Attachment 1

Proposed Changed Pages

Unit 2

Page 3/4	4-29
Page 3/4	4-30
Page B3/4	4-6
Page B3/4	4-7
Page B3/4	4-8
Page B3/4	4-9
Page B3/4	4-10
Page B3/4	4-14

FIGURE 3.4-2 FARLEY UNIT 2 REACTOR COOLANT SYSTEM HEATUP LIMITATIONS APPLICABLE FOR THE FIRST 8 EFPY

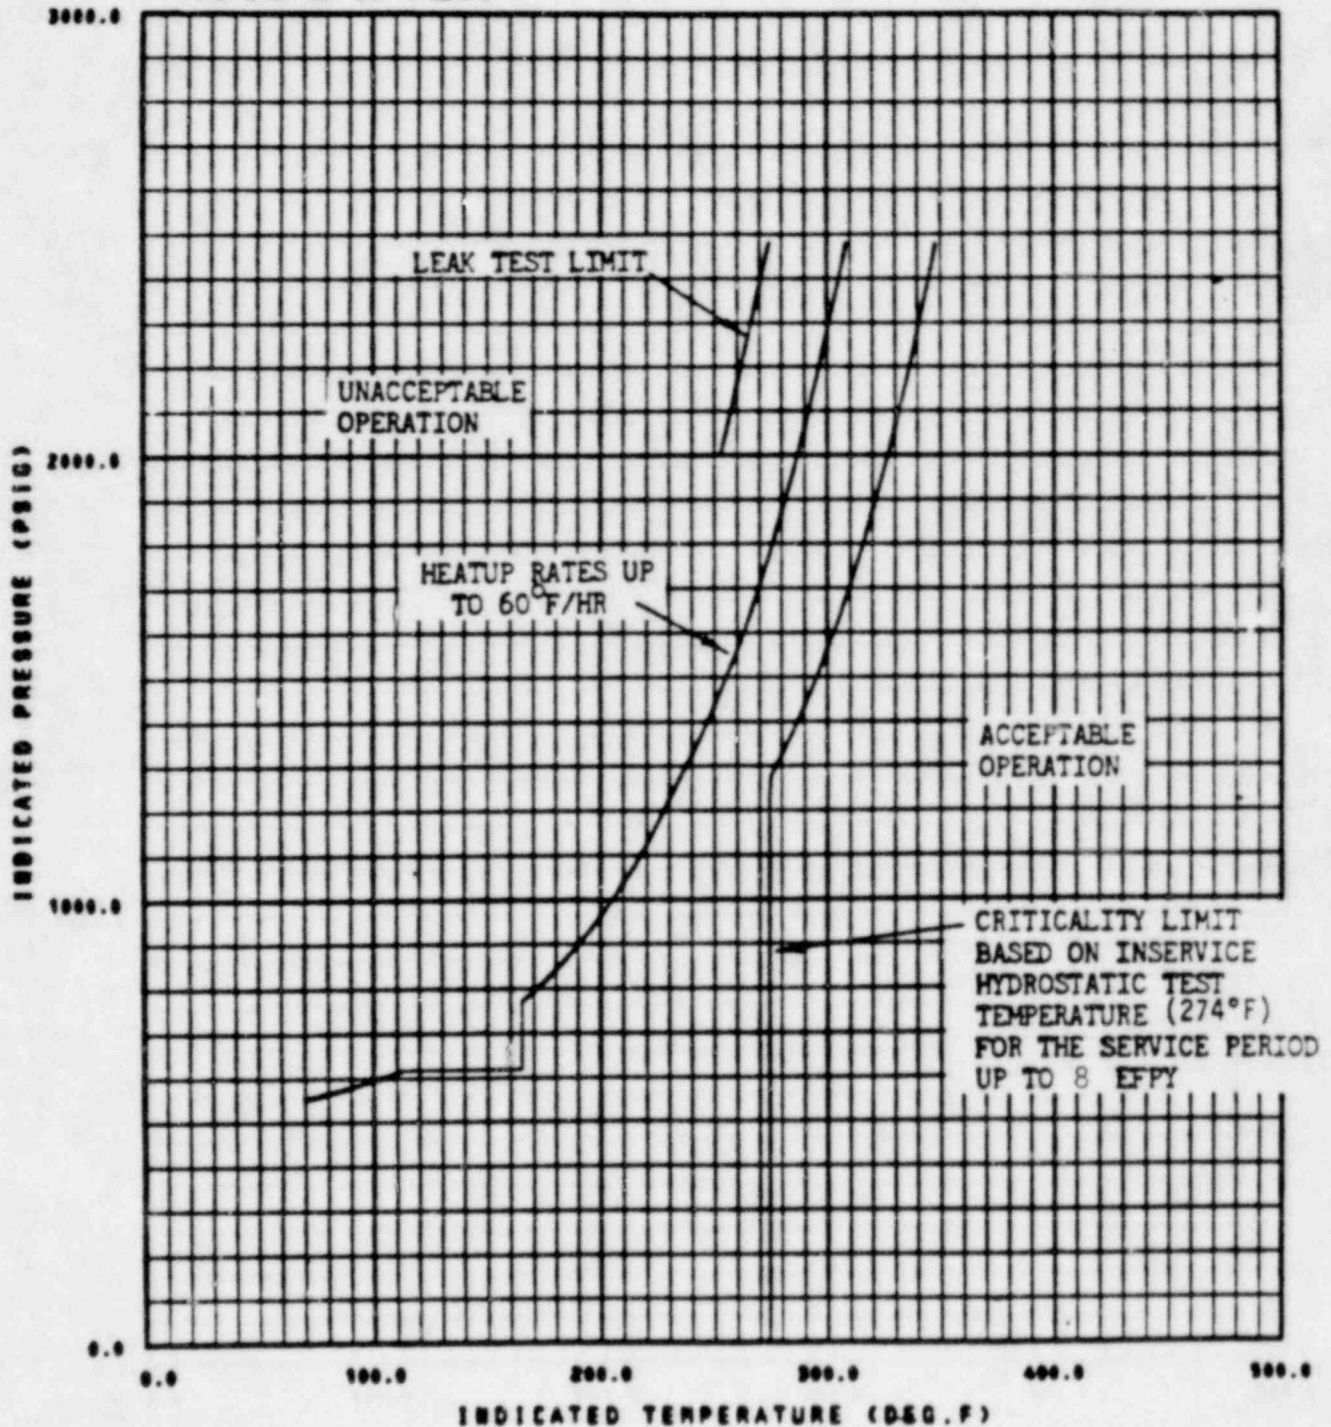
MATERIAL PROPERTY BASIS

CONTROLLING MATERIAL : R. V. INTERMEDIATE SHELL  
 COPPER CONTENT : 0.20 WT%  
 PHOSPHORUS CONTENT : 0.018 WT%  
 INITIAL RT<sub>NDT</sub> : -10°F  
 RT<sub>NDT</sub> AFTER 8 EFPY : 1/4T, 146°F  
 : 3/4T, 83°F

CURVES APPLICABLE FOR HEATUP RATES UP TO 60°F/HR FOR THE SERVICE PERIOD UP TO 8 EFPY

FIGURE 3.4-3 FARLEY UNIT 2 REACTOR COOLANT SYSTEM COOLDOWN LIMITATIONS APPLICABLE FOR THE FIRST 8 EFPY

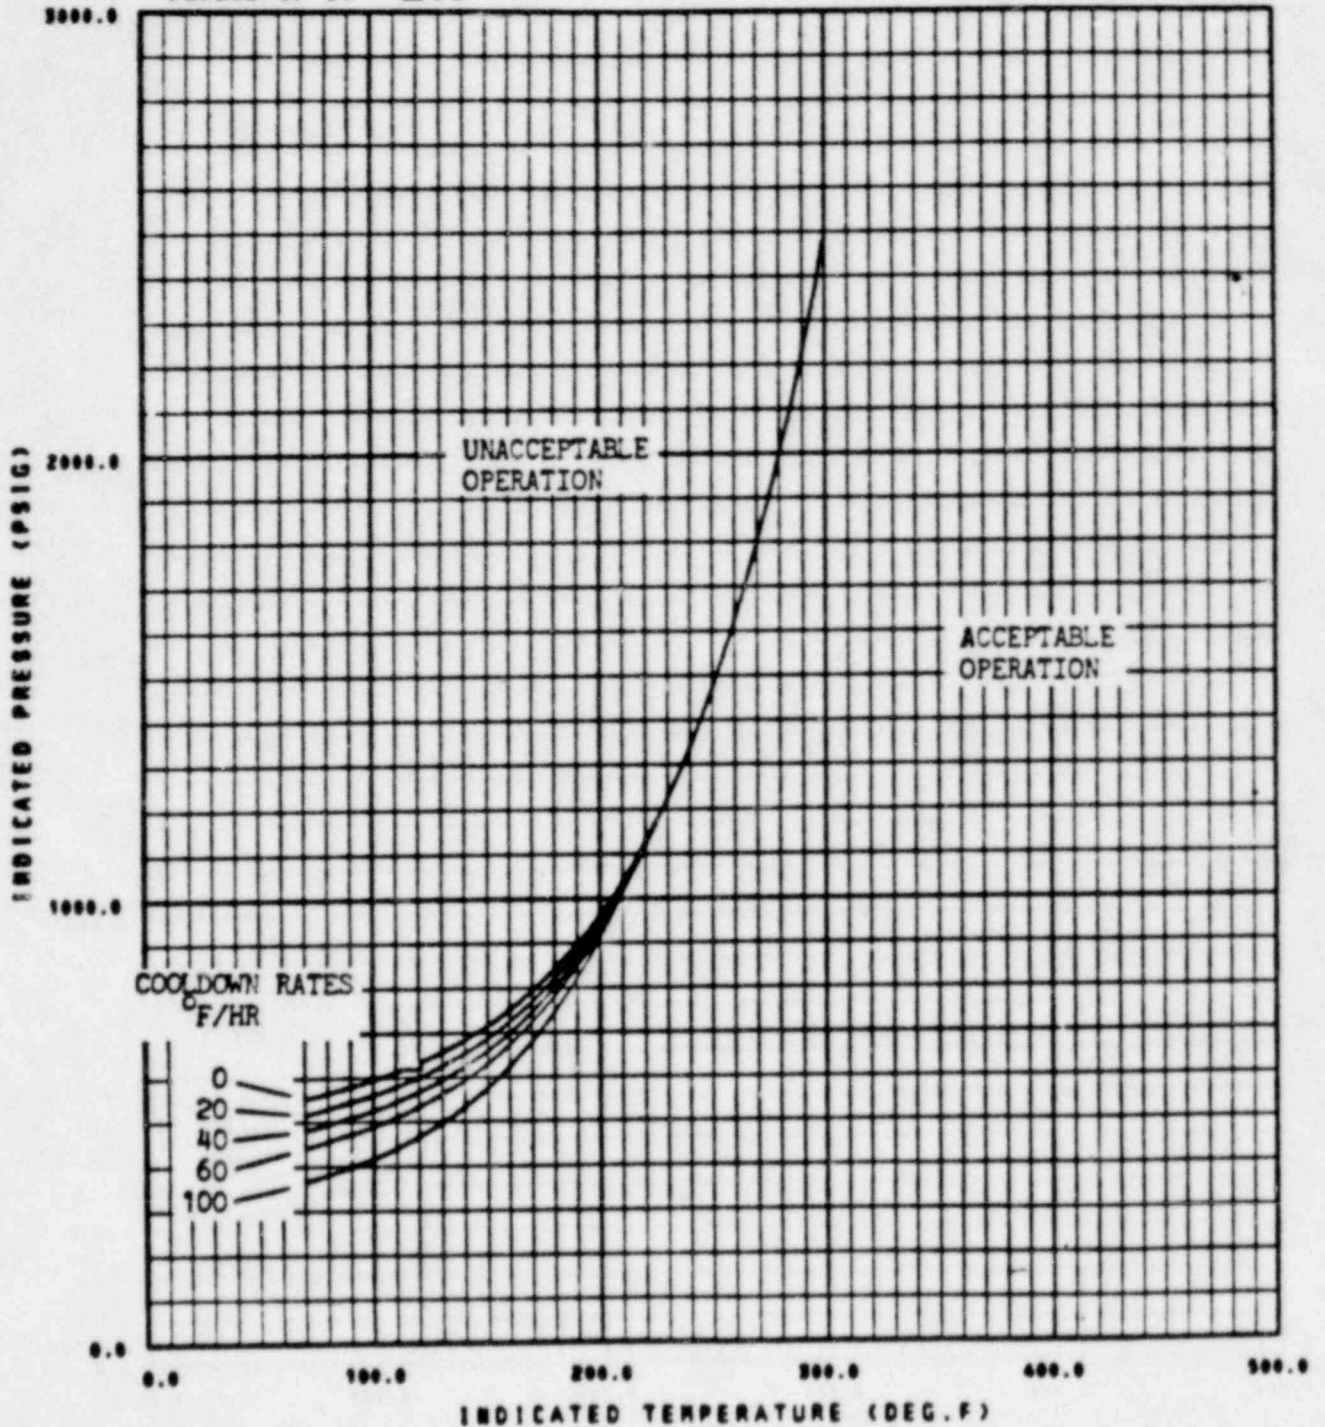
MATERIAL PROPERTY BASIS

CONTROLLING MATERIAL : R. V. INTERMEDIATE SHELL  
 COPPER CONTENT : 0.20 WT%  
 PHOSPHORUS CONTENT : 0.018 WT%  
 INITIAL RT<sub>NDT</sub> : -10°F

RT<sub>NDT</sub> AFTER 8 EFPY : 1/4T, 146°F  
 : 3/4T, 83°F

CURVES APPLICABLE FOR COOLDOWN RATES UP TO 100°F/HR FOR THE SERVICE PERIOD UP TO 3 EFPY
